**OFFICE OF ASSISTANT CHIEF OF STAFF FOR INSTALLATION MANAGEMENT
U.S. ARMY FORT MONMOUTH
P.O. 148
OCEANPORT, NEW JERSEY 07757**

22 June 2017

**SUBJECT: *Landfill Meeting Summary 12 April 2017*
Fort Monmouth, Oceanport, New Jersey
PIG000000032**

Attachment 1- FTMM-18 Revised Landfill Boundary

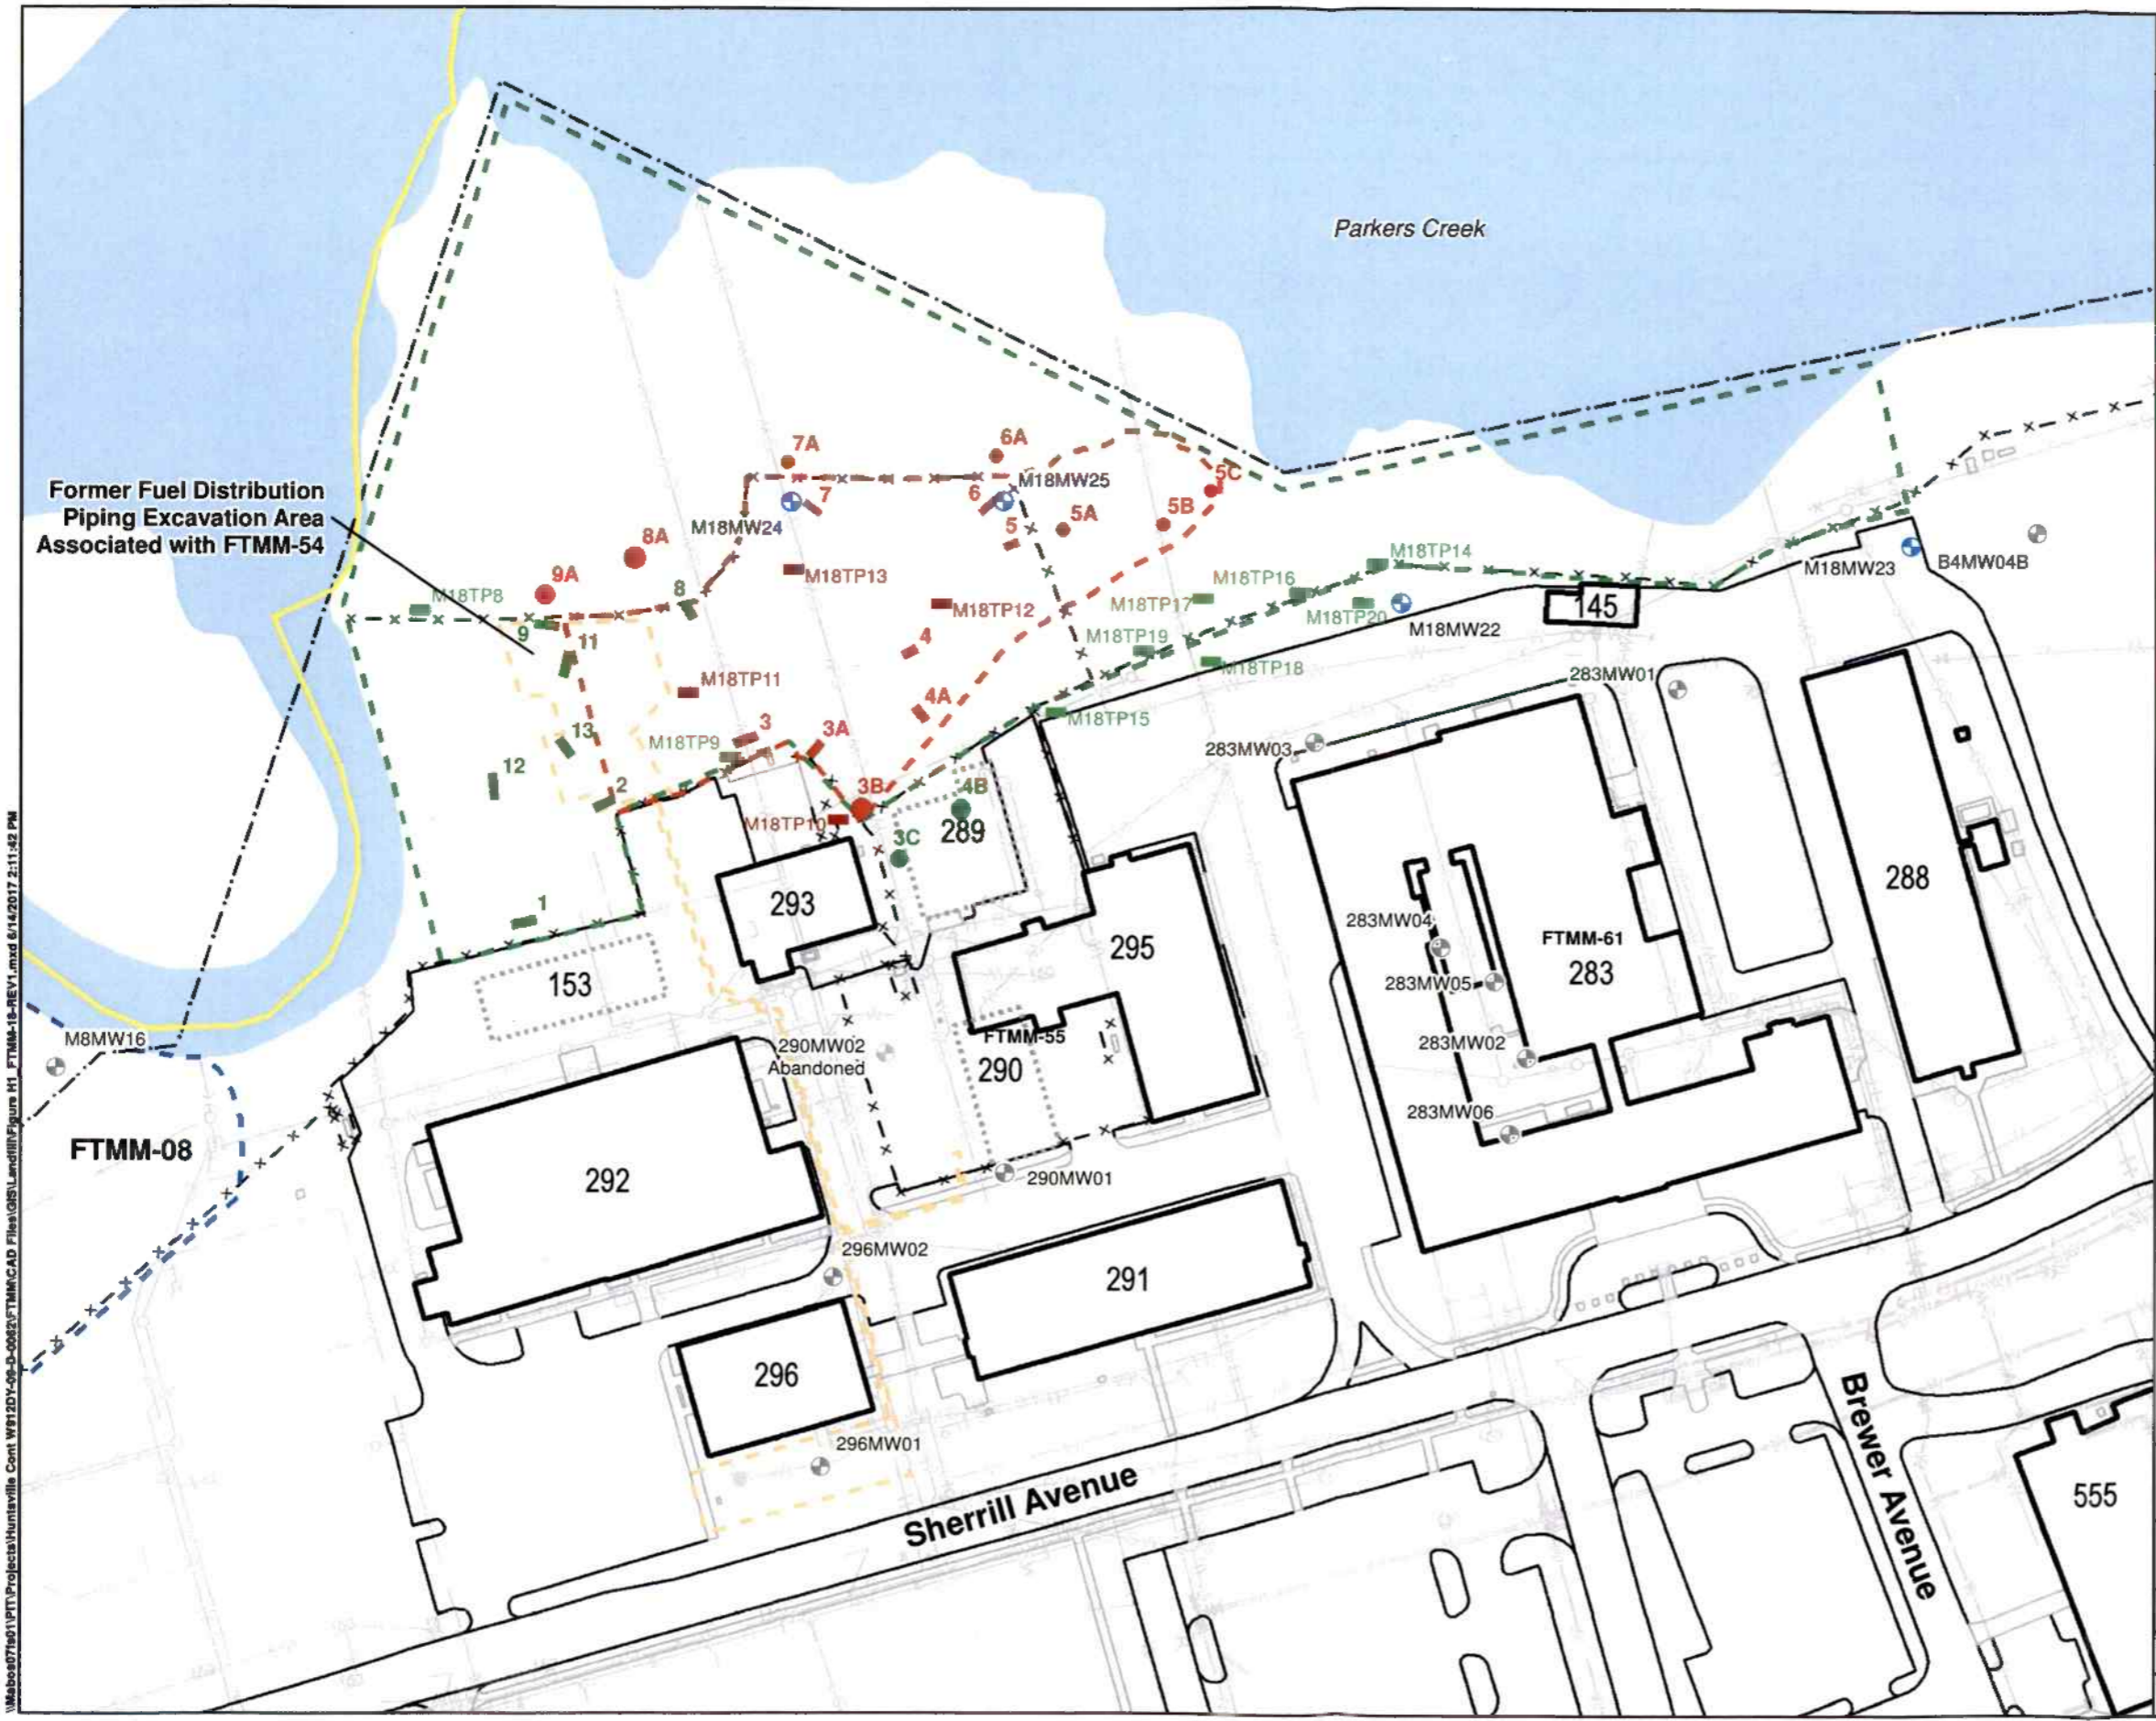
A2. COMMENT: No mention was made of M18TP10 (highlighted on Figure H1), immediately west of 3B; didn't we say that would be included under the cap?

A3. COMMENT: Although I've made notations on April 2017's Figure H1 regarding movement of the boundary in the north (fence line at 6, 6A, 7 etc.) based on the site visit, I

would request a revised boundary map prior to my departure so the new case manager has an accurate representation to go by, particularly as regarding the eastern portion

A2. RESPONSE: The cover system will either be extended over test pit M18TP10 or the material will be excavated and consolidated under the FTMM-18 soil cover to the extent that the integrity of the building and the adjacent concrete slab will not be compromised.

A3. RESPONSE: It was agreed that the landfill cap will extend to the northern fence line along the areas of 6, 6A, 7, 7A, 8, 8A, etc. Additionally, agreed upon was that the cap will be extended to test pits 5A, 5B, and 5C located north of the drainage swale and the cap will not be extended over to test pits (M18TP15 through M18TP20) located on the south side of the drainage swale. A revised FTMM-18 map showing these revised landfill boundary limits is included as **Attachment 1**.
